ERRATA 2

DENVER WATER

DENVER INTERNATIONAL AIRPORT AIRSIDE FIRE HYDRANT ASSEMBLY

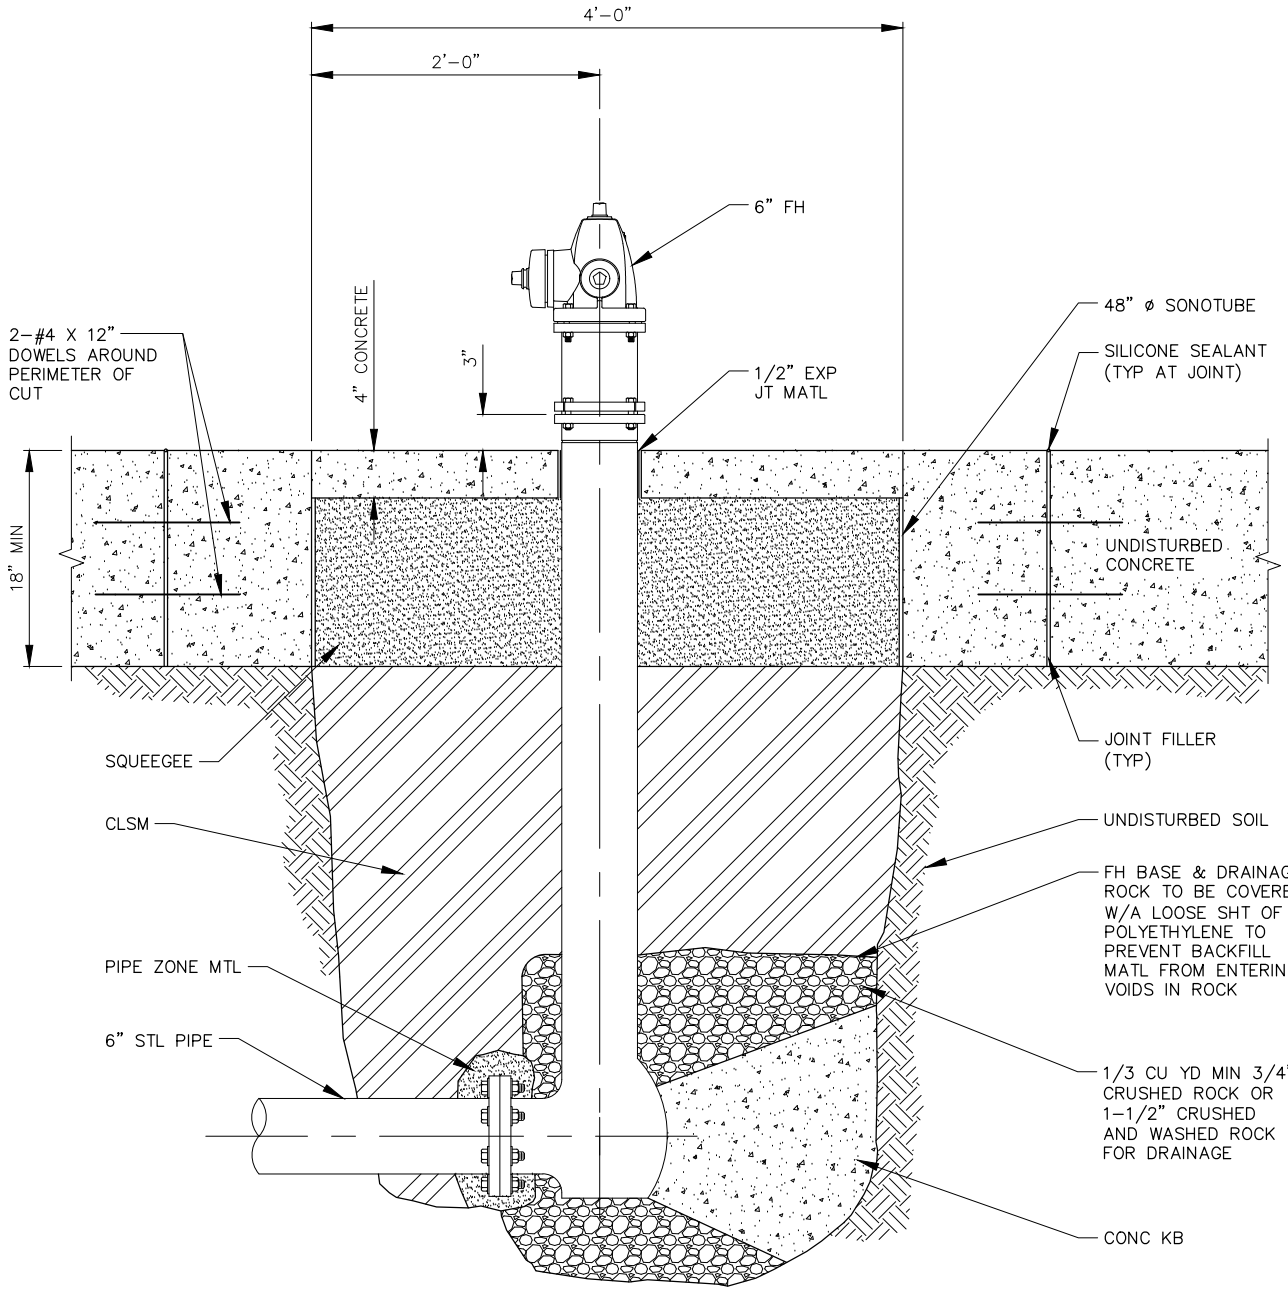
1. NO HORIZONTAL OR VERTICAL BENDS ARE ALLOWED IN THE FIRE HYDRANT BRANCH.
2. PROVIDE A 48-INCH DIAMETER SONOTUBE AROUND CIRCUMFERENCE OF FIRE HYDRANT.
3. COORDINATE CONSTRUCTION ACTIVITIES WITH DENVER INTERNATIONAL AIRPORT AND DENVER WATER CONSTRUCTION INSPECTION.
